TO: Mercedes-Benz Principals, General Managers, Sales Managers, Service Managers, Parts Managers	FROM: Anthony Washington, Department Manager, Regulations and Certifications
Re: Recall Campaign Launch Notification Model 907 (Sprinter) Model Year 2020 Check Torque on Front Door Hinge Screws	DATE: June, 2021

Campaign No. 2021060008 June, 2021

SUBJECT: **Model 907 Sprinter, Model Year 2020**
Check Torque on Front Door Hinge Screws

D72.10-A007-79

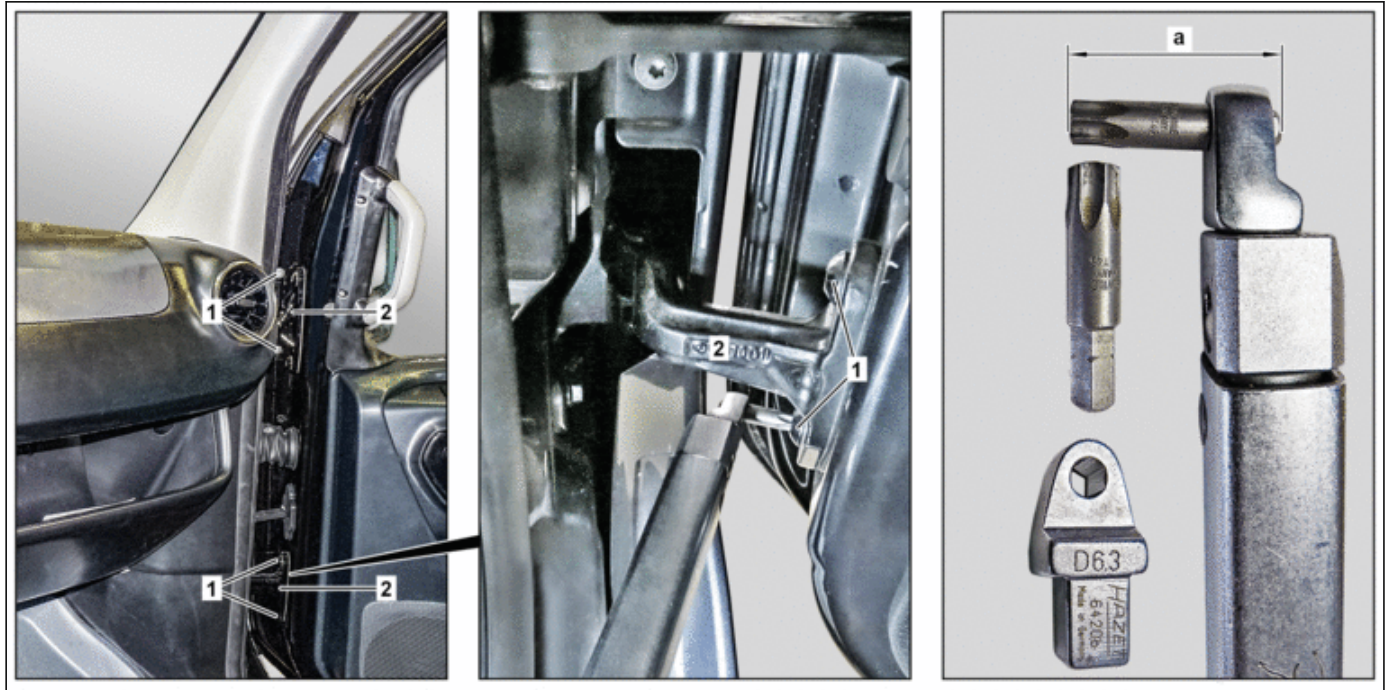
Check threaded connections of hinges (2) on **both** front doors.

Check		
1	Check, whether the vehicle is affected by the measure.	For authorized Mercedes-Benz service partners, only the entry in the Extended VEGA Application (EVA) system, in the "Current" tab, is decisive. An additional test of the affected vehicles in the workshop information system (WIS) or vehicle list is thereby not necessary.	
2	Fully open each front door.		
3	Check front door for play on screws (1) and hinges (2). 	To do so, move front door e.g. abruptly. If front door exhibits play on the screws (1) or hinges (2), ↓ Adjust front door. If front door does not exhibit any play on the screws (1) or hinges (2), ↓ continue with operation step 4.	AR72.10-D-0550TS
	Tighten threaded connection		
4	Tighten screws (1). Note on calculation of tightening torque when using insertion or socket tools with various effective lengths	If the respective front door does not exhibit any play on the screws (1) or hinges (2). Use torque wrench attached at low eye-level height. Observe dimension (A). Screw/bolt, hinge to front door	AH00.00-P-0015-01CW BA72.10-N-1010-01TS

Number	Designation	Model 907
BA72.10-N-1010-01TS	Screw/bolt, hinge to front door	Nm 23
